Pemulwuy Concept

Objection - 29 November 2018

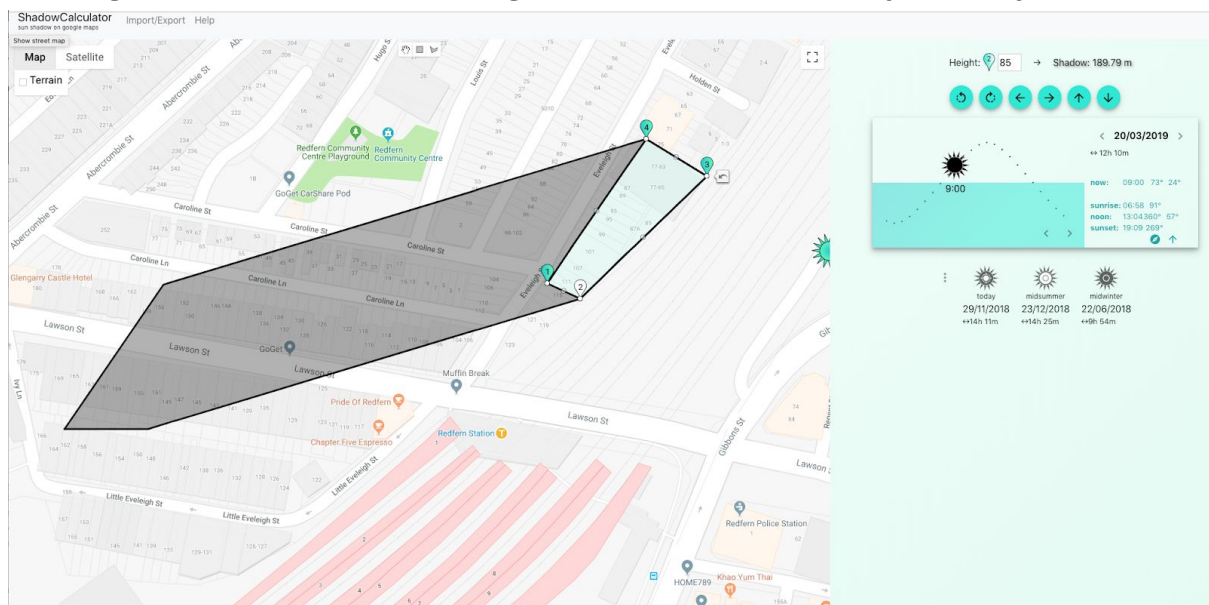
Using the proposed heights listed on table 17² I've rendered a draft shadowing map³ for 9am on the 20th March. This reveals the **shocking** impact such a tall building will have on the natural light available to the nearby 2-storey terraces.

On page 5 of the report “The Department’s assessment concludes the increase in height of the Precinct 3 building ...from 8 to 24 storeys...would not have an adverse impact on amenity in terms of overshadowing, overlooking, impact on

views". ⁴ **This is incorrect and completely misleading.** Being in a conservation area, I cannot make my windows larger to alleviate the loss of light. This building should not be any taller than the approved 8-storeys (which is already extreme and a compromise for the area).
